Mr. H. Haynes
3 Trevelgue Road
Newquay
TR7 3LY

INSPECTION OF BUILDING WORK CARRIED OUT - GAMES ROOM AT 3 TREVELGUE ROAD

Photo 1 - Rear retaining wall, reinforcement in incorrect position

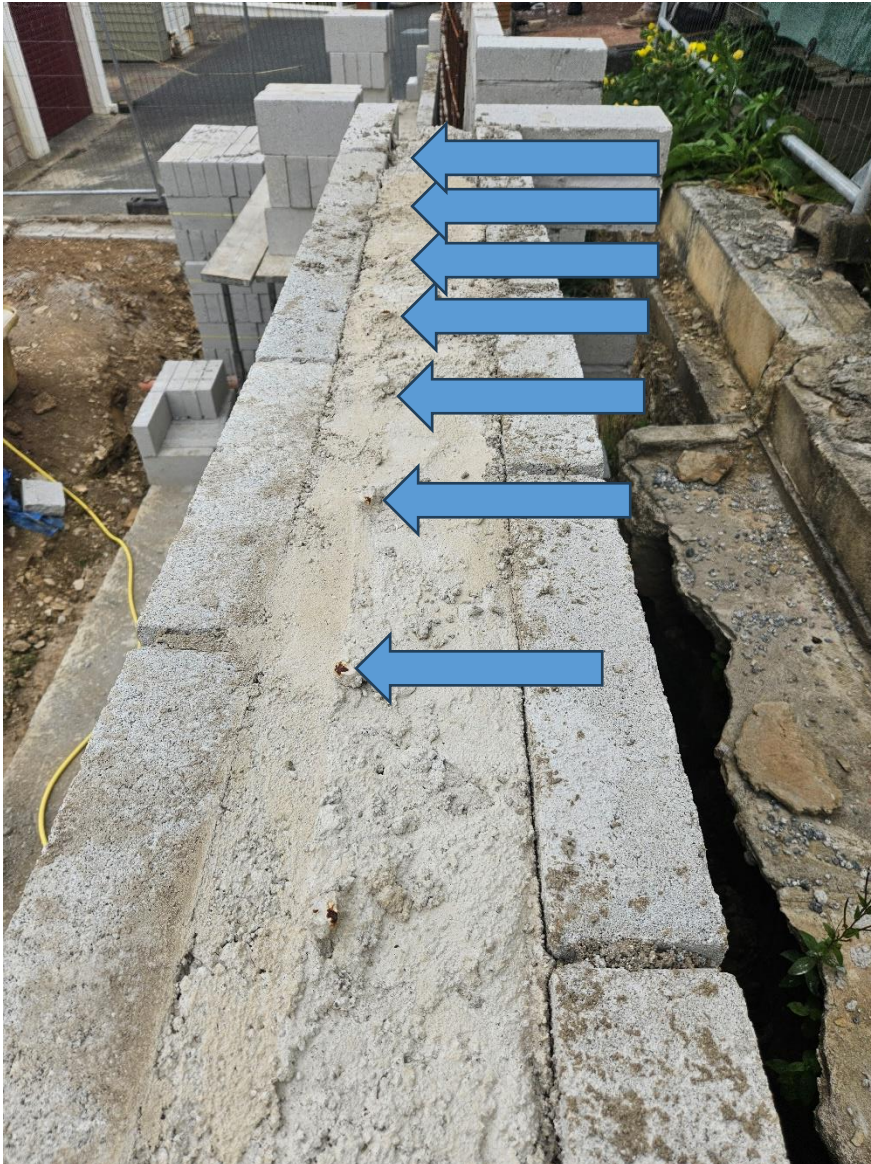
The reinforcement in the North wall of the games room has been positioned correctly in the base, and subsequently in the correct position within the cavity, however when the concrete was poured the reinforcement has been allowed to move forwards, and in two locations is against the face of the inner leaf of masonry. This will mean that the reinforcement is essentially ineffective in these areas. The blue arrows in photograph 1 below show the position of the reinforcement in wall where concrete has been poured full height. Photograph 2 shows the reinforcement in the section of retaining wall that has been partially filled with concrete; it can clearly be seen how the reinforcement has been allowed to move within the cavity. To rectify this issue, the concrete will need to be broken away, and the reinforcement re-set in the correct position. The concrete will then need to be repoured, and adequately vibrated to ensure no voids or air bubbles exist.
